ASB-1027

Service Bulletin

Subject: TM-732A Protection of Q201 in 430 MHz Unit
1993

430 MHz TX-RX Unit
X57-4000-11
Foil Side View

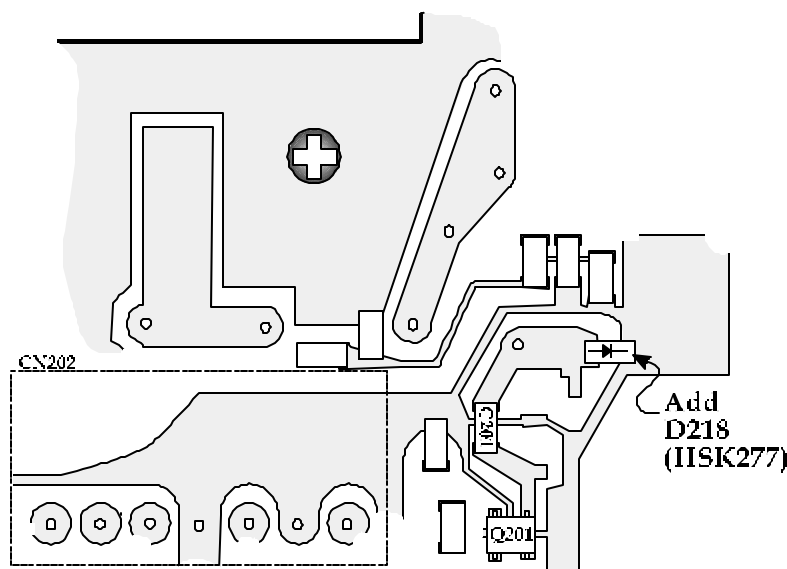
Q201 the first RF Amplifier in the 430 MHz unit fails at random.

Addition of diode D218 in parallel with diode D214 in the RA line provides increased surge protection for Q201.

Qty	Description	Kenwood Part No.	Circuit Description
1	Diode	HSK277	D218
